**FINAL DRAINAGE REPORT**

**LOT 1 & LOT 2 CROSSROADS MIXED USE**  
**FILING NO. 2**  
**EL PASO COUNTY, COLORADO**

FEBRUARY 2023

**M&S CIVIL RESPONSES ARE IN RED**

# LOT 1 & LOT 2 CROSSROADS MIXED USE FILING NO. 2 EXISTING CONDITIONS DRAINAGE MAP

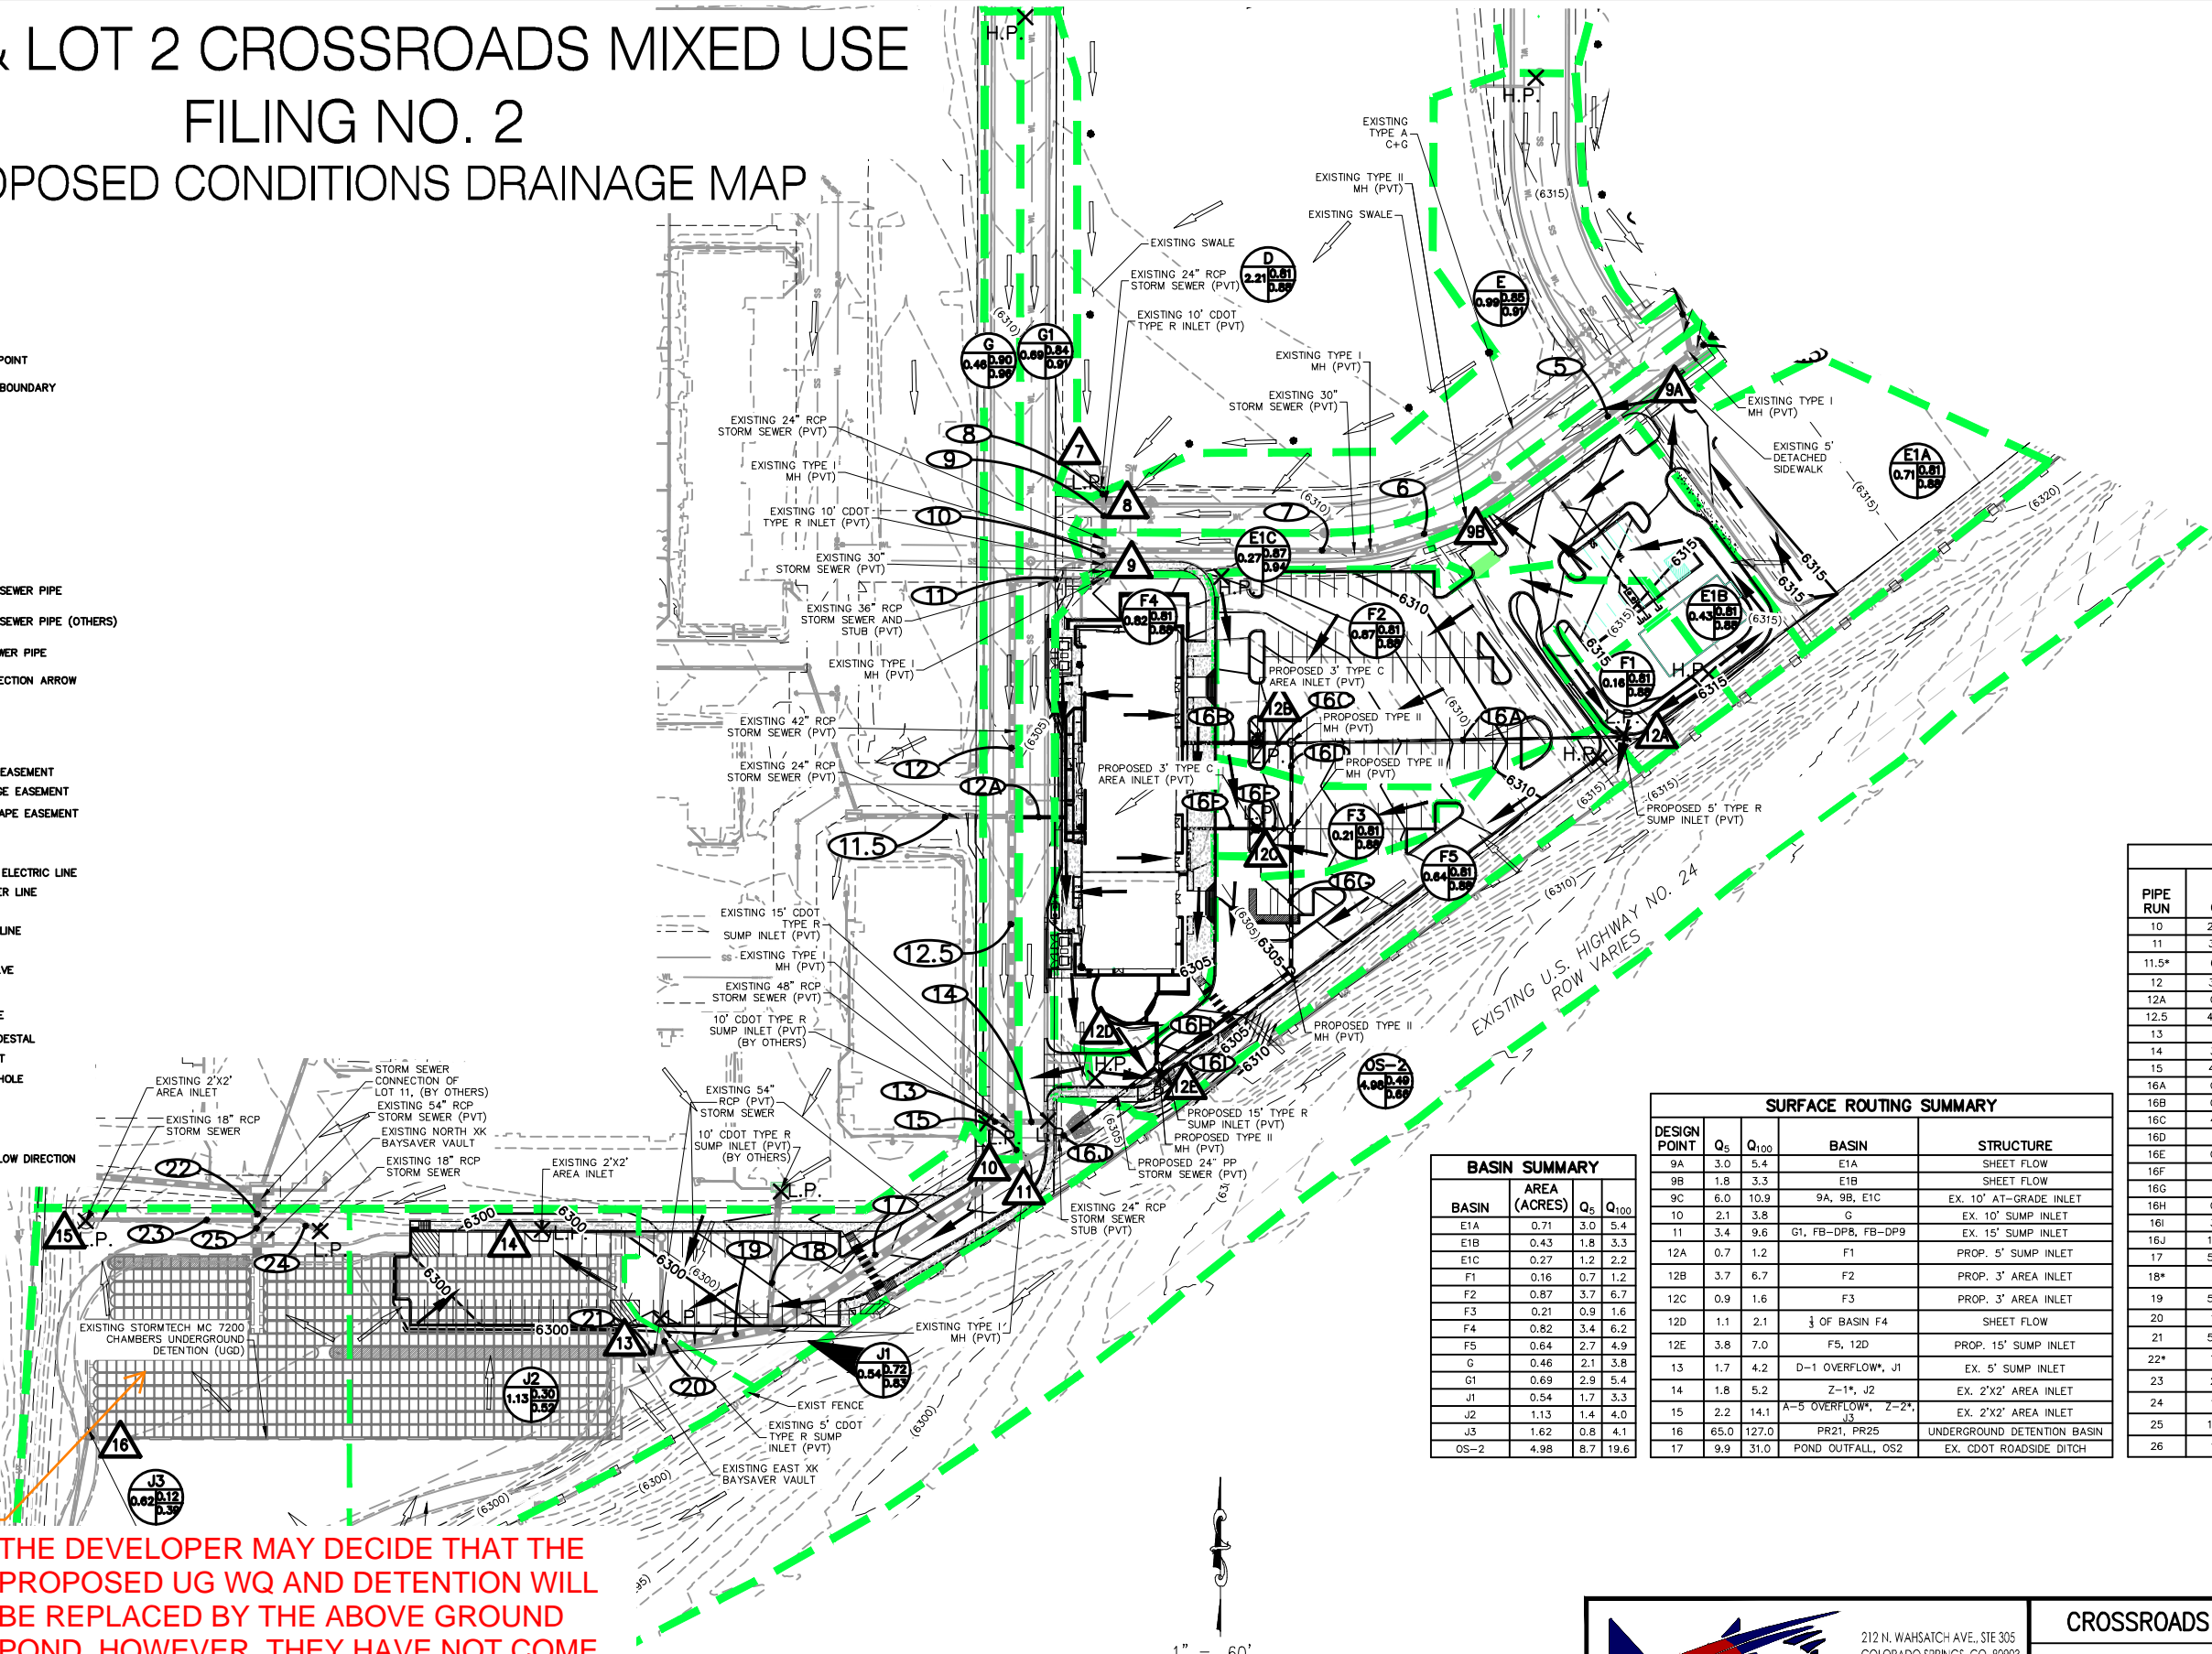
revise map to show above ground pond if that's what was decided.
